# Access Compliance Report

## Public Rights-of-Way

Intersection ID: 52490	Main Street: WHITEHALL_EXECUTIVE_CENTER_DR	Cross Street: PRAGUE_LN	Location: S
ADA ID: 5F094439A61A	Ramp Type: Perp	Initial Pass/Fail: Fail	Overall Compliance: No
Severity Score: 13.75			
Codes/Mitigation Info/Possible Solution		Field Measurements/Component Compliance

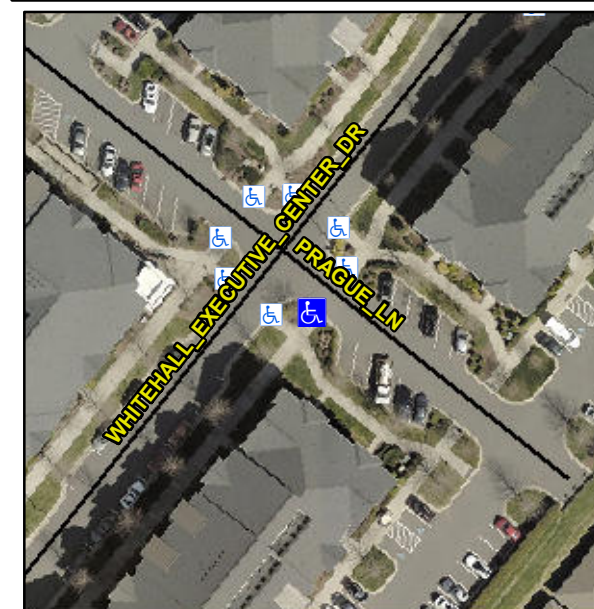
**Not Found, R304.2.2, R304.5.3**

Compliance	Description	Data	Compliance	Description	Data
N/A	Ramp Length (in)	70.0	No	Ramp Slope (%)	8.7
Yes	Ramp Width (in)	93.0	No	Ramp XSlope (%)	2.5
N/A	Flare Type LT	N/A	N/A	Flare Type RT	N/A
N/A	Flare Slope LT (%)	N/A	N/A	Flare Slope RT (%)	N/A
N/A	Flare Traversable LT?	N/A	N/A	Flare Traversable RT?	N/A
N/A	Landing Length (in)	N/A	N/A	DWS Provided?	N/A
N/A	Landing Width (in)	N/A	N/A	DWS Contrast?	N/A
N/A	Landing Slope (%)	N/A	N/A	DWS Length (in)	N/A
N/A	Landing X Slope (%)	N/A	N/A	DWS Full Width?	N/A
N/A	Landing Curb? (Y/N)	N/A	N/A	DWS Offset (in)	N/A
N/A	Shared Landing?	N/A			
N/A	Gutter Ponding?	N/A	N/A	Gutter Slope (%)	N/A
N/A	Gutter Lip Ht (in)	N/A	N/A	Gutter X Slope (%)	N/A
N/A	Painted X Walk1?	No	N/A	Painted X Walk2?	N/A
	X Walk 1 Direction	To NE		X Walk 2 Direction	N/A
N/A	X Walk 1 Width (in)	N/A	N/A	X Walk 2 Width (in)	N/A
	X Walk 1 Slope (%)	1.1		X Walk 2 Slope (%)	N/A
	X Walk 1 X Slope (%)	2.2		X Walk 2 X Slope (%)	N/A

**Remove & Replace Entire Ramp.**
